RS-15-255

R. E. Ginna Nuclear Power Plant  
Renewed Facility Operating License No. DPR-18  
NRC Docket No. 50-244

Subject: Response to NRC Audit Review Request for Additional Information Regarding  
Fukushima Lessons Learned - Flood Hazard Reevaluation Report

**Response to NRC Audit Review Request for Additional Information Regarding  
Fukushima Lessons Learned - Flood Hazard Reevaluation Report**

**Figure 10-3: FLO-2D-generated impact forces during the PMF combined effect flood (pounds per foot)**

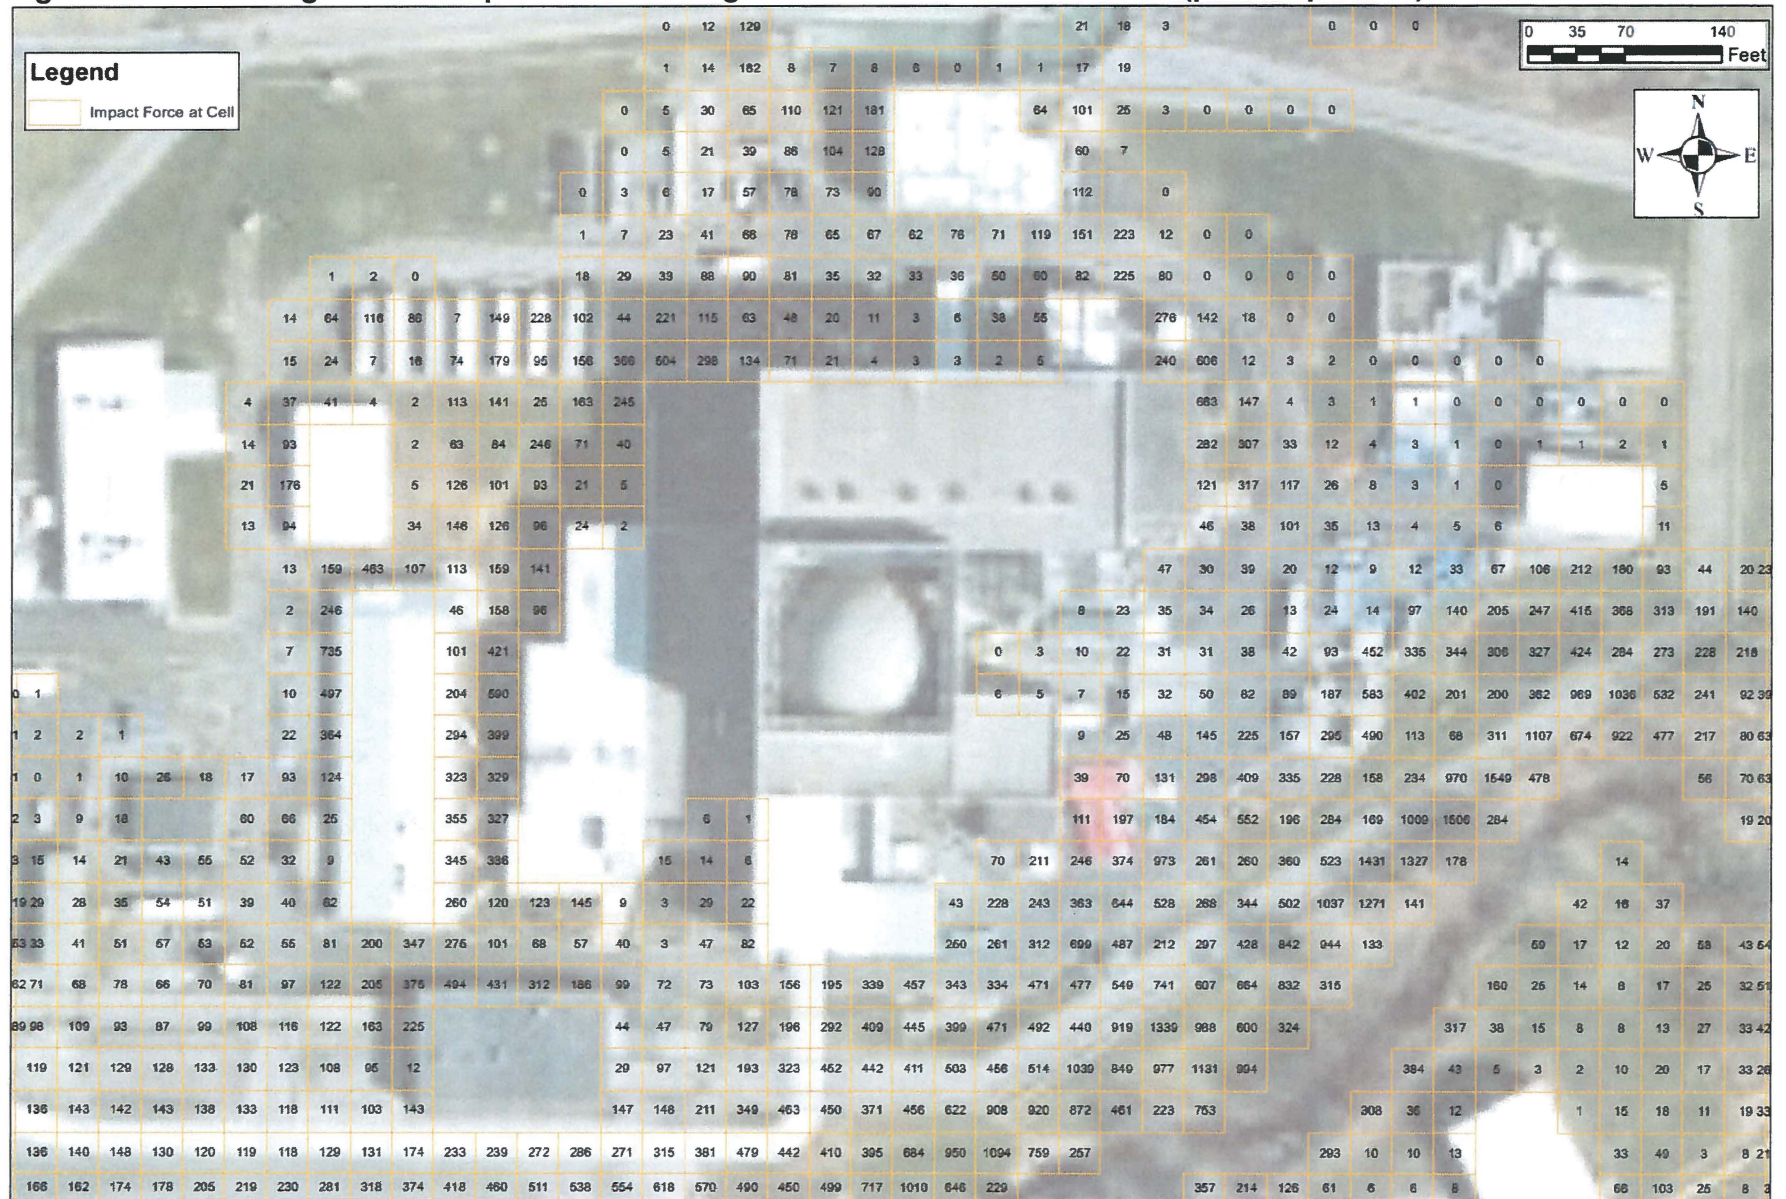
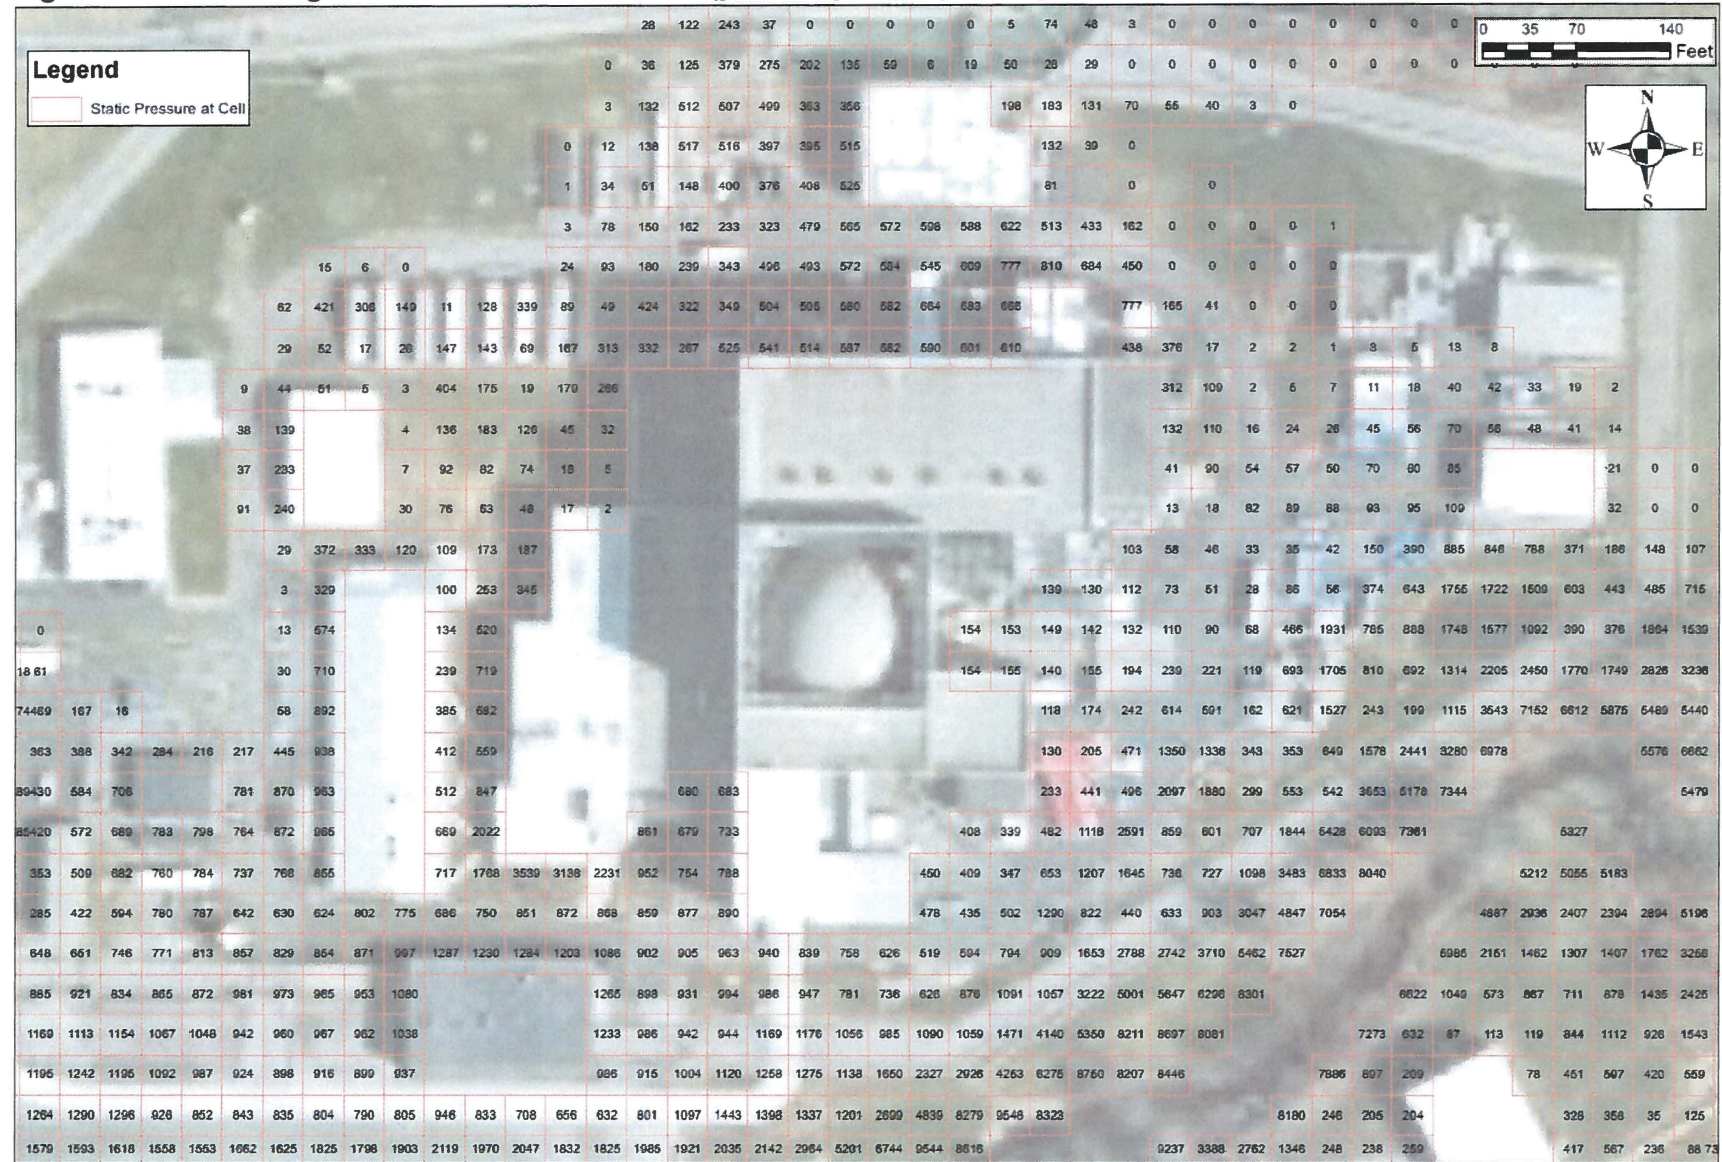
**Request:** Provide the flood height and associated effects (as defined in Section 9 of JLD-ISG-2012-05) that are not described in the FHRR for mechanisms that trigger an Integrated Assessment. This includes the following quantified information for each mechanism (as applicable):

- Wind waves and run up,
- Hydrodynamic loading, including debris,
- Effects caused by sediment deposition and erosion (e.g., flow velocities, scour),
- Concurrent site conditions, including adverse weather,
- Groundwater ingress

In response to the Information Need request, FLO-2D was used to approximate impact pressure loading as a result of the PMF. The results are provided in Figures 10-3 and 10-4. FLO-2D uses the Deng impact pressure equation, which is a function of maximum velocity (regardless of direction) and the density of water (FLO-2D, 2012). The impact pressure is reported as a force per unit length (impact pressure times flow depth). FLO-2D also reports static pressure based on flow depth and the specific weight of water (FLO-2D, 2012). The results are anticipated to be bounded by existing loading requirements for tornado/missile loading, with the exception of

the Auxiliary Building. Flow velocities in the vicinity of the Auxiliary Building are relatively limited.
